RE: North Sydney Council's Beaches Link EIS Submission

8.6. Beaches Link and Gore Hill Freeway Connection EIS Submission

BL&GHF technical working paper: Traffic and Transport (Jacobs 2020)

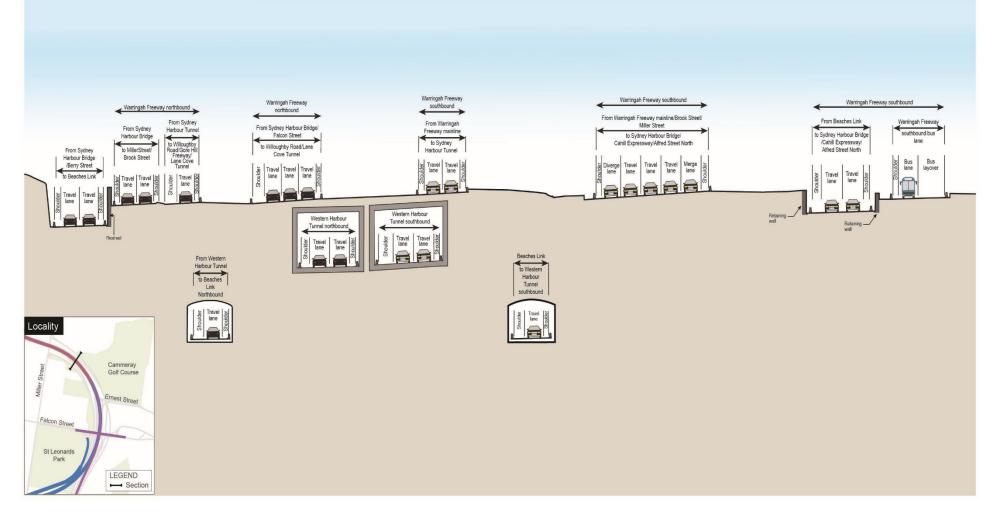
This does not mean that the BL&GHF proposals have any less of an impact on North Sydney amenity or the function of its local traffic network, with significant additional Lower North Shore traffic using the Pacific Highway (southbound), Berry Street and proposed Warringah Freeway access lanes to access the northbound BL portal on the Warringah Freeway.

The WHT and BL projects are described in the EIS as "integrated" projects, this integration is limited to a single traffic lane connecting BL to WHT (see cross-section below) leaving the remaining two lanes to enter the Sydney CBD. This suggests that providing a link between the Northern Beaches and Sydney's strategic motorway network (WestConnex) is now only a small part of BL's intended function.
